Re: Abengoa Mojave Solar Project (09-AFC-5): Second Supplemental Written Response to Data Request Set 1B (Nos. 1-86) for Water Resources

Soils and Water Resources (21-61)

Figure B-1. Comparison of steady-state model results for 1931: (a) from the updated model in Groundwater Vistas; (b) from Stamos et al. (2001).

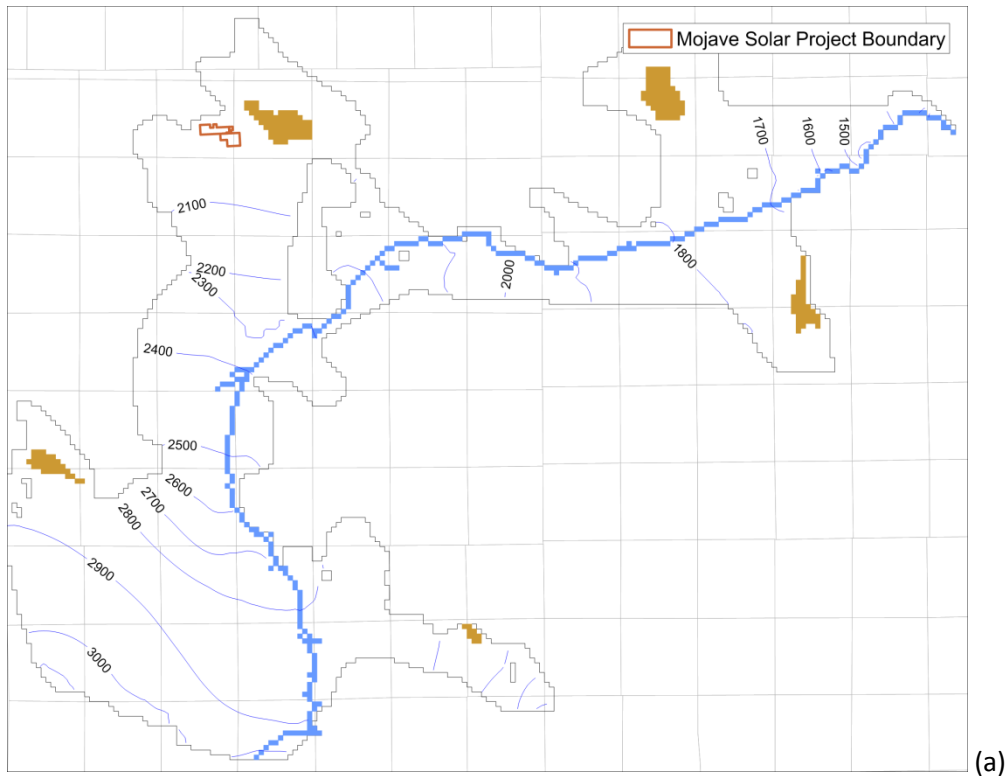
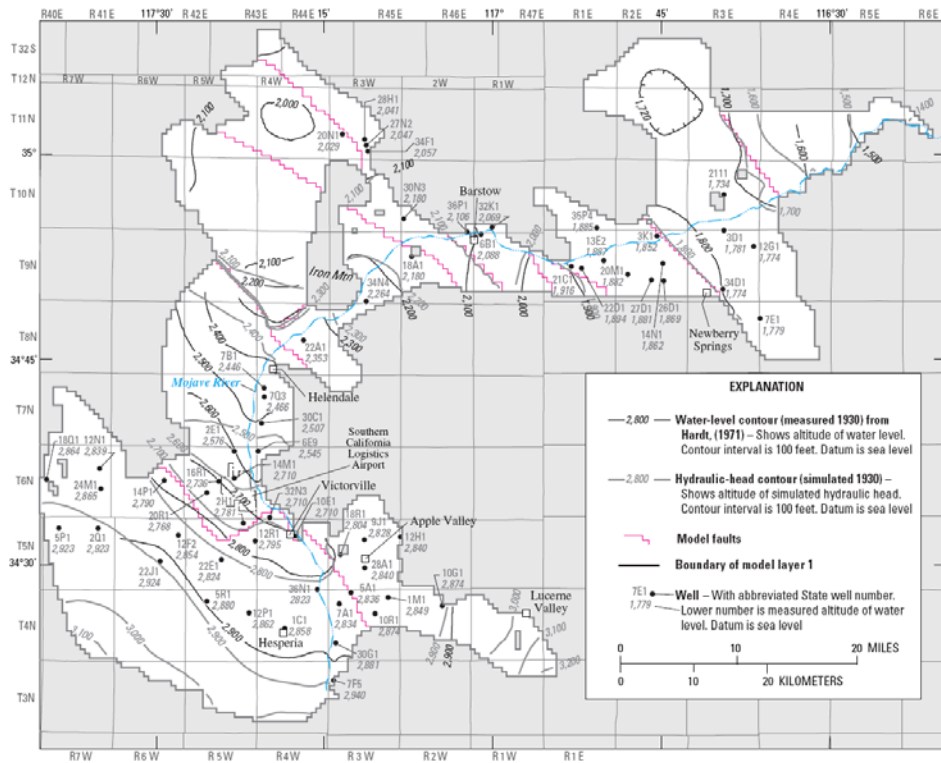
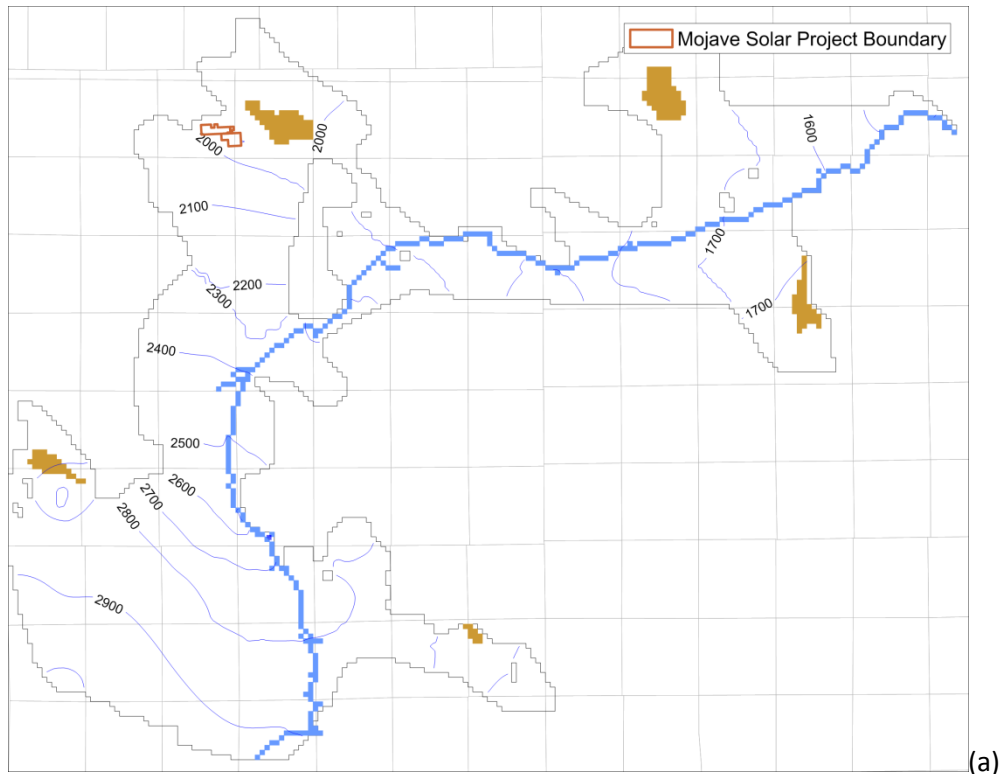
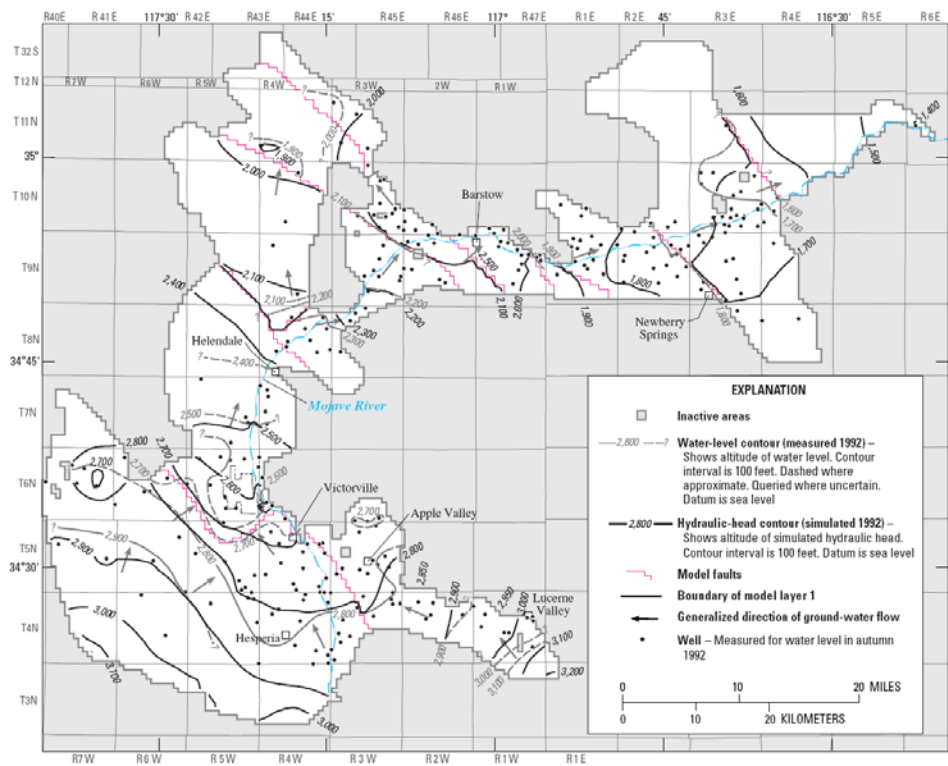
In our previous submittal, we adapted the USGS model of the Mojave basin (Stamos, et al. 2001). We have further adapted that model in response to Staff requests made during the review process:

1. The input files for the steady “pre-development” model erroneously had a well that added 60 cfs to the model instead of the 10 cfs called for in the text of the Stamos Report (WRIR 01-4002). The steady model was re-run and its results were used as initial conditions for the transient 1931-2050 predictive models.
2. There were a few inconsistencies identified between the USGS reported pumping rates for some wells in the transient simulation. The corrected rates were provided by CEC Staff consultant, HydroFocus.
3. When Groundwater Vistas imported the transient recharge data, a constant recharge rate was added across the entire model after 2010. This was corrected by re-copying the recharge array in the predictive model.

Figures B-1 and B-2 (attached at the end of these responses) were updated to reflect the pumping rates changes provided by HydroFocus. Although the discrepancies between the our previous submittal and the results of Stamos were small and mostly located outside of the Harper Valley basin, the revised model matches more closely.

Figure 21-3. Total dissolved solids concentrations (mg/L) for well 11N04W32A that is near the Abengoa Solar Energy Project proposed wells.

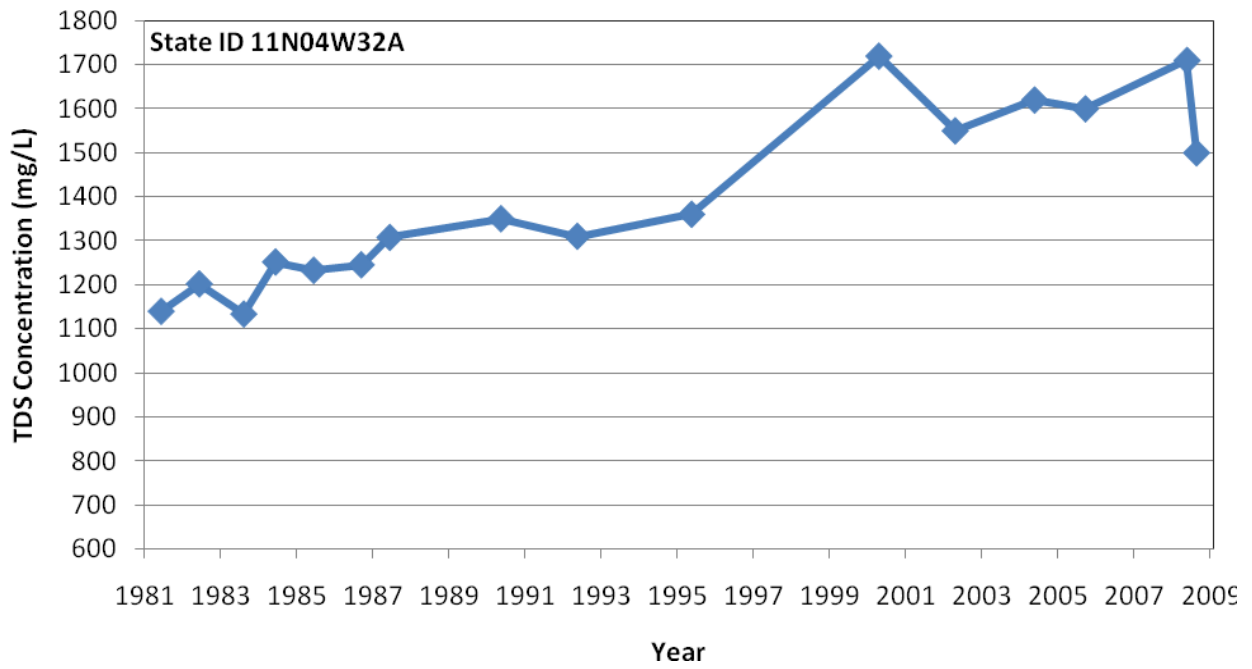
Additional Information Required:

- A. TDS hydrographs for wells near the Abengoa Solar Project Site.
- B. A table of available water-quality results for the Harper Valley Groundwater Basin.

- A. Attached Figures 21-3, 21-4, and 21-5 are TDS hydrographs for wells that had more than three data points and are near the Abengoa Solar Project Site. The TDS data was obtained from the USGS. TDS concentrations are shown to generally increase from historical levels (either 1950s or 1980s).
- B. Table 21-1 provides the water-quality results for wells within the Harper Valley Groundwater Basin and is found on the following pages.

Figure 23A-1(a). Pathlines originating from Harper Dry Lake (yellow area) to Abengoa Solar Energy Project proposed wells. Model simulation dev1 (calibrated model).

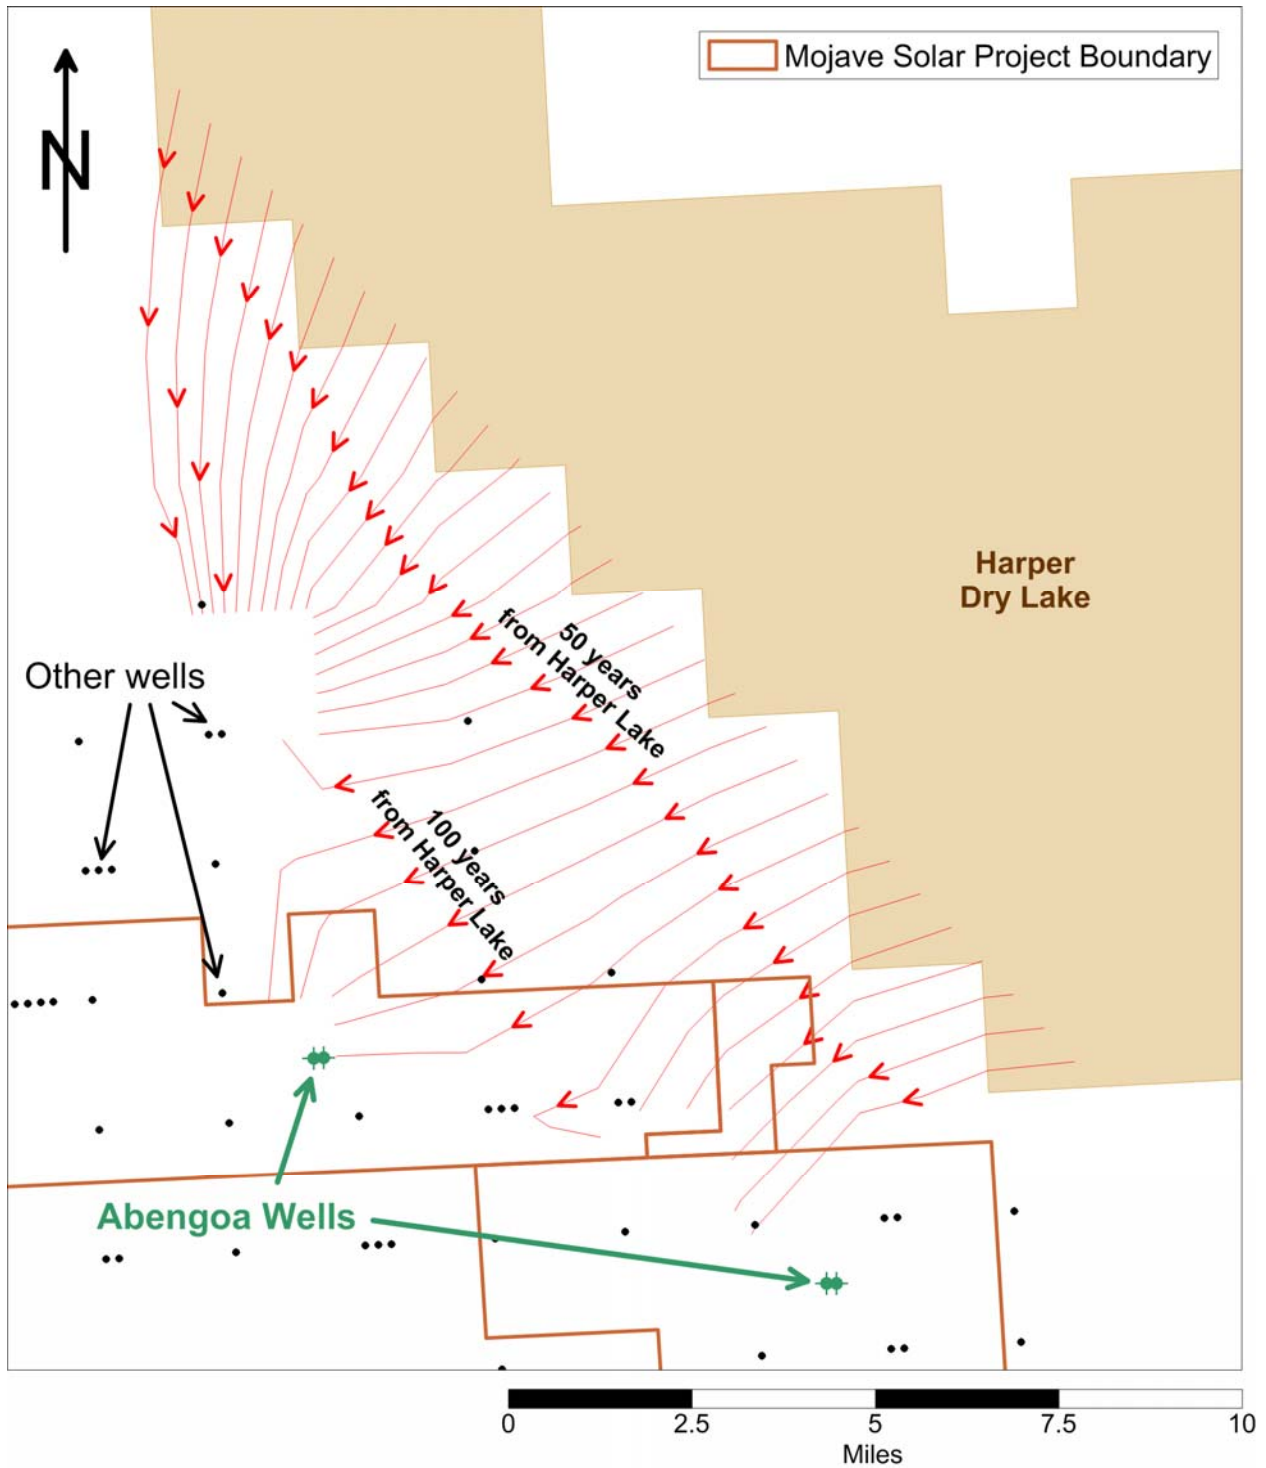
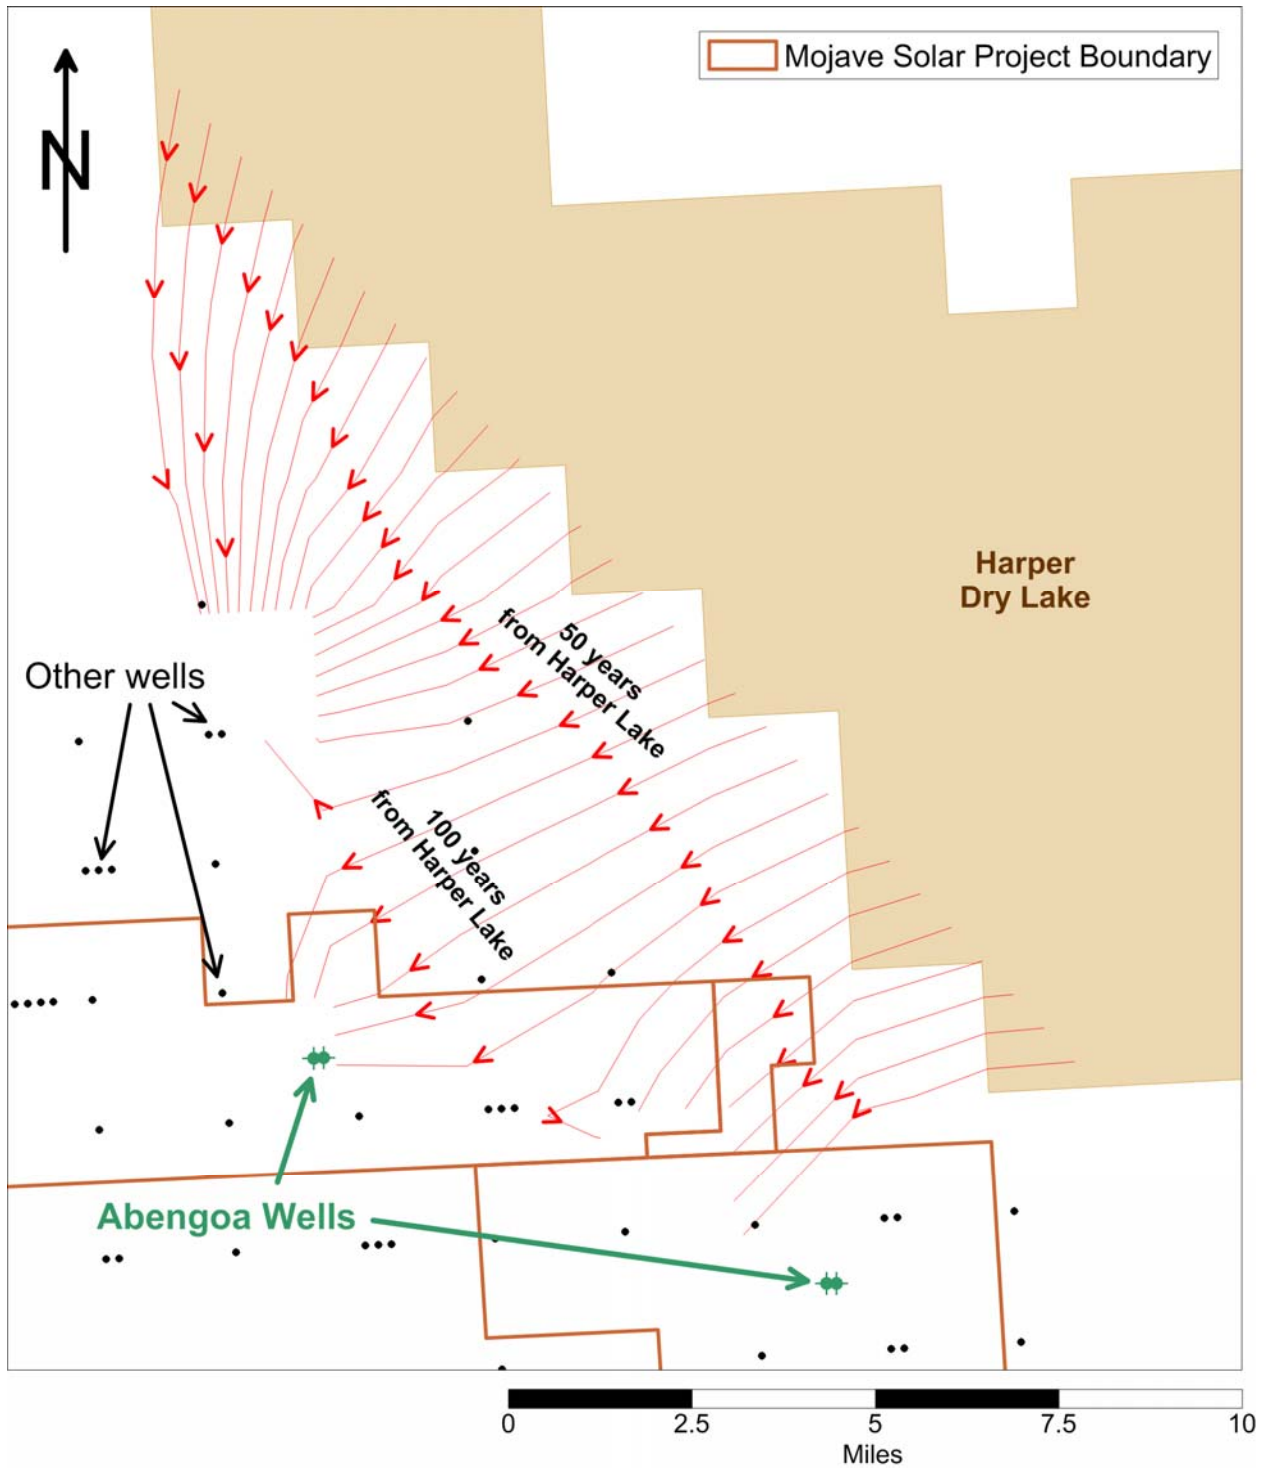
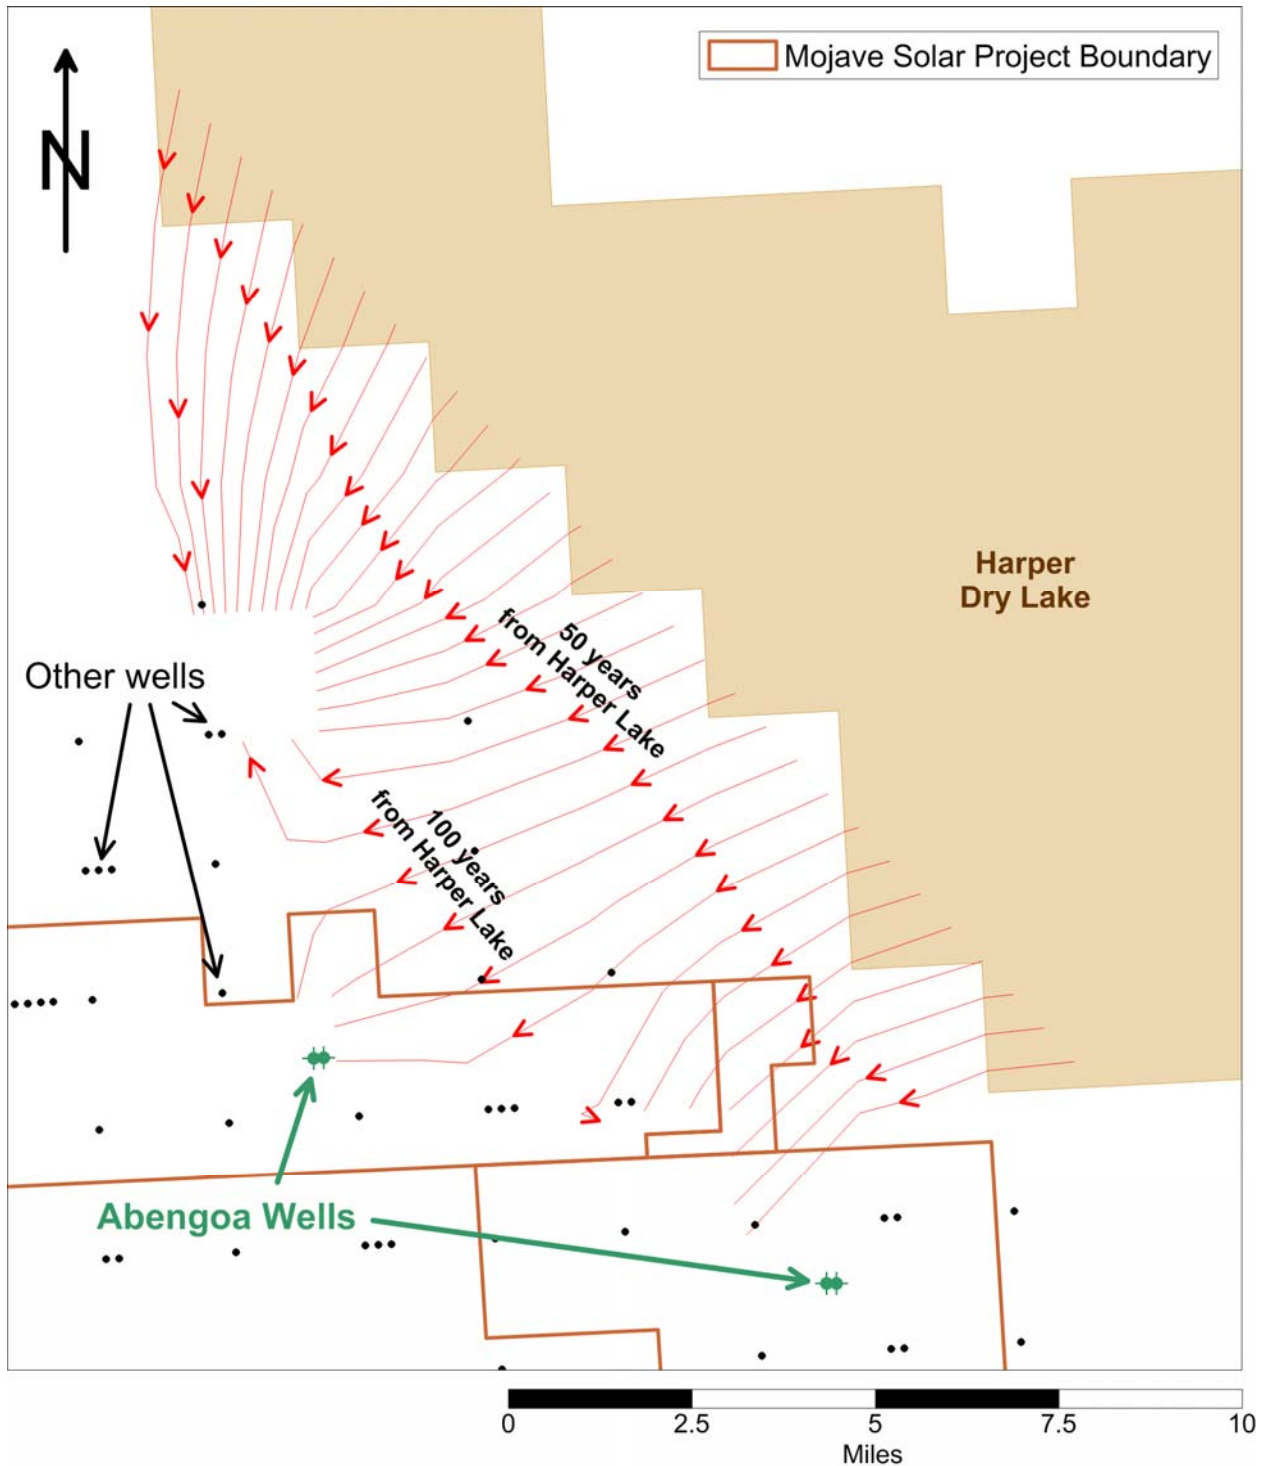
Please provide results of a MODPATH or similar particle tracking analysis to show the capture zones of the project wells (with simultaneous operation of wells at Luz Solar Energy Generation System (SEGS) XI and XII power plants) with continuous pumping at the maximum annual production rate for periods of 10, 20, and 30 years.

Figures 23A-1(a-c), show the results of a USGS MODPATH particle tracking analysis. As shown in Figure 23A-1(a-c), path lines that travel from and beneath Harper Lake terminate in the near vicinity of the proposed Abengoa wells.

Travel times are shown on the figure as arrows along the path lines; there is a 50-year travel time between each pair of arrows. It is noted that the travel time is dependent on two assumptions about the aquifer: (1) the aquifer porosity value, n ; and (2) the thickness of the porous formation that is actively available for groundwater flow, H . To adjust the travel time for a different set of assumptions, use the formula below:

Based upon our assumptions of $H_{pred} = 400 \text{ ft}$, $n_{pred} = 0.1$ and H_{adj} and n_{adj} , taken from MODPATH, pathlines show particle travel times of 100 years or more to the Abengoa Wells.

It is noted that after a telephone discussion with John Fio (February 2010), it was determined that only the “dev1”, “dev1-hi-k”, and “dev2” scenarios would be executed for pathline tracing purposes. This suite of runs was chosen because the “hi-k” and “dev2” runs will tend to offer the shortest travel times of the various simulations. Long travel times are not considered to be an issue for the facility.
